FIELD SAFETY NOTICE / PRODUCT NOTIFICATION

Subject: ExacTrac 6.0 Intra-Fraction Snap Verification: potentially incorrect software hint icon and result text for monoscopic X-ray Monitoring in combination with implanted markers.

Product Reference: ExacTrac versions 6.0.1 and 6.0.2 only (Image Guided Radiation Therapy Patient Positioning System).

Brainlab Identifier: **CAPA-20130221-000248**

Figure 1: X-Ray Monitoring tab after Snap Verification - unaffected X-ray image displaying actual implanted marker positions deviating from the tolerance areas, but incorrect hint icon and result text.

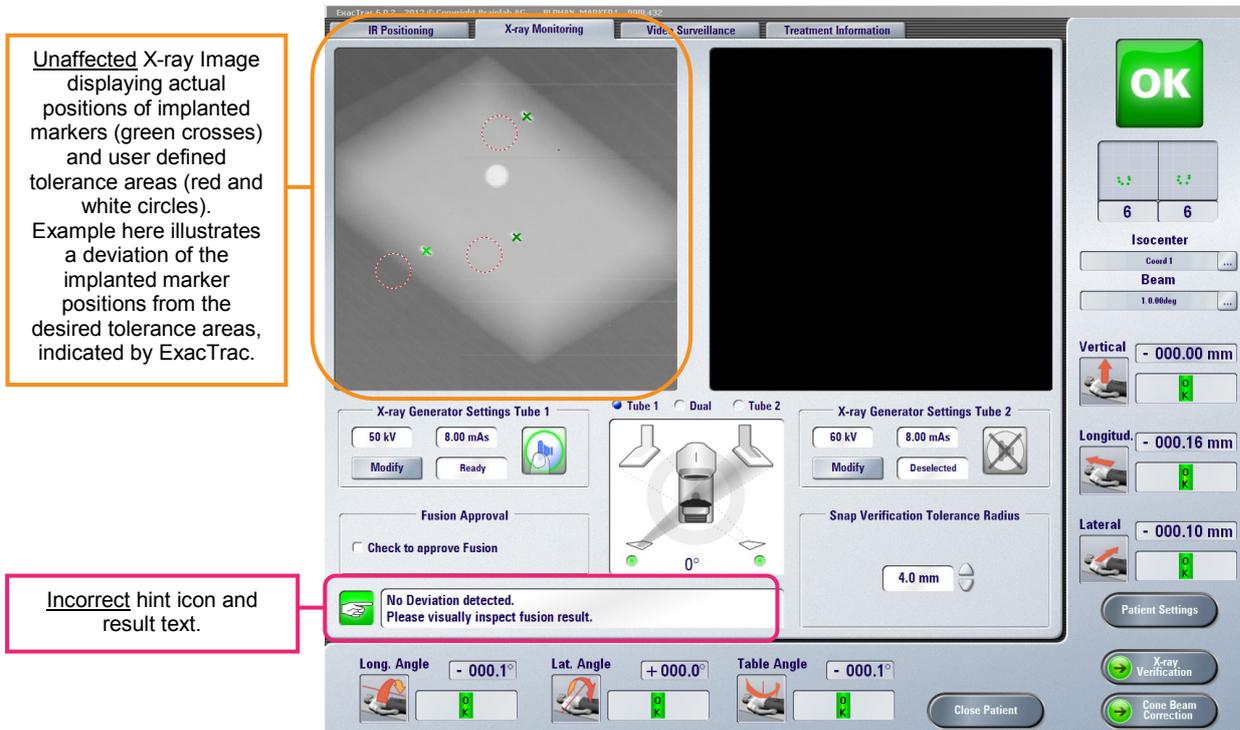
After performing a Snap Verification, that is a monoscopic Intra-Fraction X-ray Monitoring using only one X-Ray tube, in combination with implanted markers, the ExacTrac 6.0 X-ray Monitoring tab might display an incorrect hint icon and result text (please refer to Figure 1): ExacTrac might incorrectly show the hint icon in green color with the result text “No Deviation detected”, despite the simultaneously displayed unaffected X-ray image showing the actual positions of the implanted markers (displayed as green crosses) potentially deviating from the user defined tolerance areas (displayed as red and white circles).

Brainlab investigation has shown that only the first monoscopic Snap verification is affected, for example after a (stereoscopic) X-ray Verification was performed, or after entering and leaving the Patient Settings, or after re-opening the patient in ExacTrac. This first monoscopic Snap Verification always displays the hint item in green color and the result text "No Deviation detected". Subsequent Snap Verifications will display the correct and intended hint icon color and result text (=corresponding to the positions displayed in the X-ray image), until a different user action as mentioned in the above examples is performed.

Always verify the result of a Snap verification within the simultaneously displayed X-ray image, as generally required. Never exclusively rely on the hint icon color and the result text only.

1. Existing potentially affected ExacTrac v. 6.0.1 and 6.0.2 customers with Intra-Fraction X-Ray Monitoring receive this product notification information.
2. Brainlab will provide a software update with this issue solved to affected customers.
Tentative planned timeline for availability: end of August 2013.
